Access Compliance Report

Public Rights-of-Way

Intersection ID: N/A	Main Street: KIRKWYND COMMONS DR	Cross Street: TRAILMOOR RD	Location: SW
ADA ID: 46C5DE41DB5E	Ramp Type: PerpDiag	Initial Pass/Fail: Fail	Overall Compliance: No
Codes/Mitigation Info/Possible Solution		Field Measurements/Component Compliance

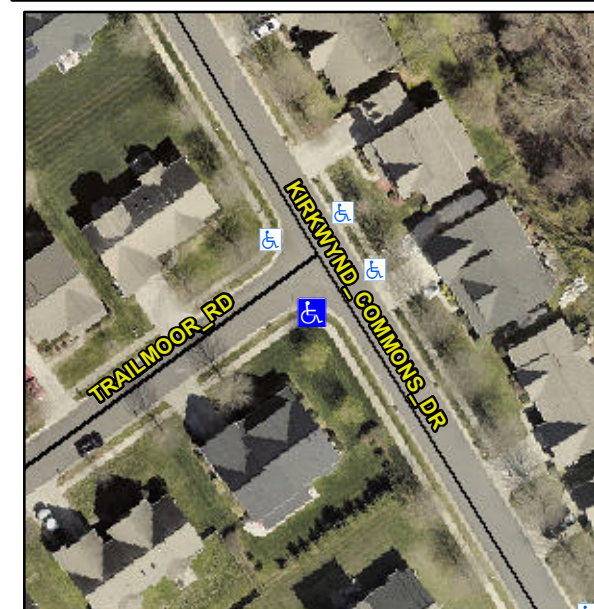
R304.5.1, R304.5.3

Compliance	Description	Data	Compliance	Description	Data
N/A	Ramp Length (in)	46.0	Yes	Ramp Slope (%)	5.8
No	Ramp Width (in)	47.0	No	Ramp XSlope (%)	2.1
N/A	Flare Type LT	N/A	N/A	Flare Type RT	N/A
N/A	Flare Slope LT (%)	N/A	N/A	Flare Slope RT (%)	N/A
N/A	Flare Traversable LT?	N/A	N/A	Flare Traversable RT?	N/A
N/A	Landing Length (in)	N/A	N/A	DWS Provided?	N/A
N/A	Landing Width (in)	N/A	N/A	DWS Contrast?	N/A
N/A	Landing Slope (%)	N/A	N/A	DWS Length (in)	N/A
N/A	Landing X Slope (%)	N/A	N/A	DWS Full Width?	N/A
N/A	Landing Curb? (Y/N)	N/A	N/A	DWS Offset (in)	N/A
N/A	Shared Landing?	N/A			
N/A	Gutter Ponding?	N/A	N/A	Gutter Slope (%)	N/A
N/A	Gutter Lip Ht (in)	N/A	N/A	Gutter X Slope (%)	N/A
N/A	Painted X Walk1?	No	N/A	Painted X Walk2?	No
	X Walk 1 Direction	To NE		X Walk 2 Direction	To NW
N/A	X Walk 1 Width (in)	N/A	N/A	X Walk 2 Width (in)	N/A
	X Walk 1 Slope (%)	2.1		X Walk 2 Slope (%)	3.0
	X Walk 1 X Slope (%)	2.3		X Walk 2 X Slope (%)	0.4

Remove & Replace Curb Ramp With Two New Directional Ramps or Equivalent.
